### Model E & L Secondary Levers

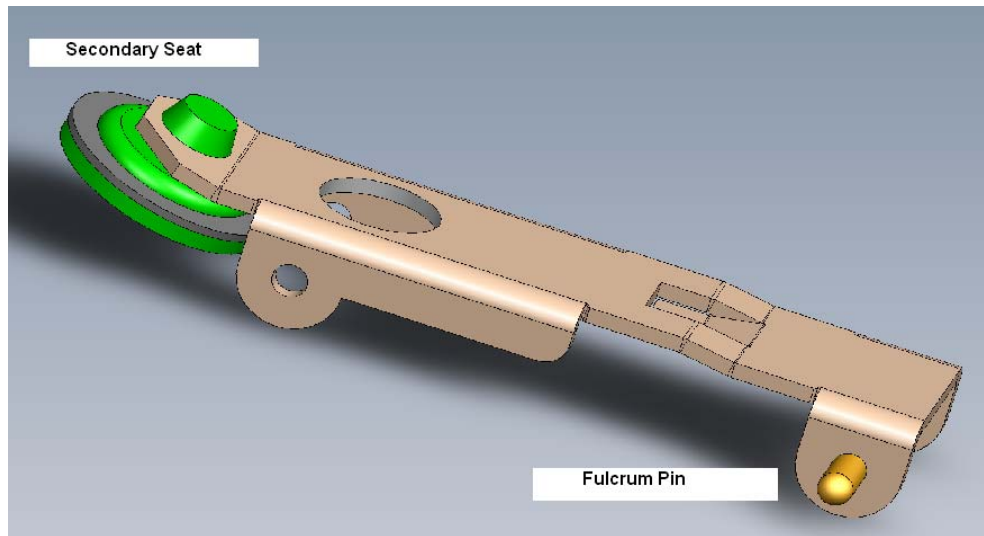
A change has been made to the model E and L repair kits. The secondary lever for the model E was pre-assembled with the fulcrum pin and secondary seat. The lever, pin and seat are now supplied as separate part items in the repair kit and must now be assembled by the rebuilder.

The secondary lever for the model L was supplied with the secondary seat pre installed. The lever and secondary seat are now supplied as separate part items and must now be installed by the rebuilder. The repair kit instructions have been updated to reflect this change.
